SIB 64 09 19

SERVICE ACTION: CHECKING HEATER HOSE FOR PROPER
INSTALLATION

E Series	Model Description	Production Date
F97	X3 M Sports Activity Vehicle	April 2019 to July 2019
F98	X4 M Sports Activity Vehicle	April 2019 to July 2019

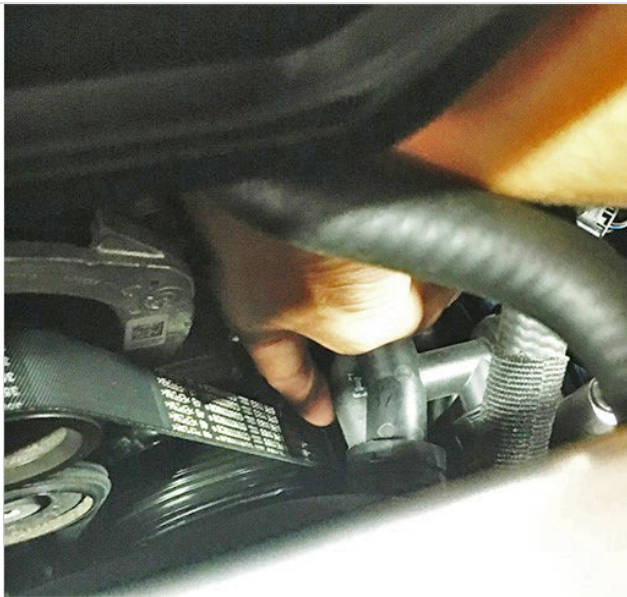
The installation area between the heater return hose and the drive belt is very limited. If the hose is not secured properly, this could cause contact with the drive belt.

Limited space between the heater hose and the drive belt, along with possible incorrect clip installation.

Check the clip for proper mounting, and fasten the heater return hose with a cable tie.

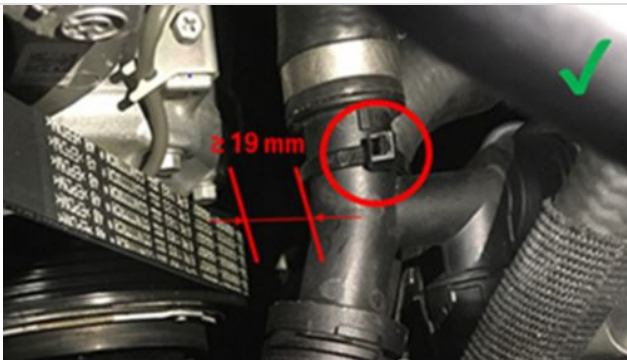
3. Locate the lower heater hose and check the distance between the drive belt and the heater return hose. A finger should fit between the drive belt and the heater return hose. If a finger fits, the clip of the heater return hose is correctly fastened.

4. If the clip is not correctly mounted, the clearance between the drive belt and the heater return hose is too small. Therefore, the hose is not secured and can be moved easily.

- If necessary, push the clip into the metal holder (circled)

6. Secure the heater return hose to the hard plastic pipe above the hose using a cable tie.

- Ensure that the cable tie is not pulled too tight
- The lock rests on the hard plastic pipe (circled)
- The approx. 19mm clearance (“finger width”) is achieved by installing the cable tie
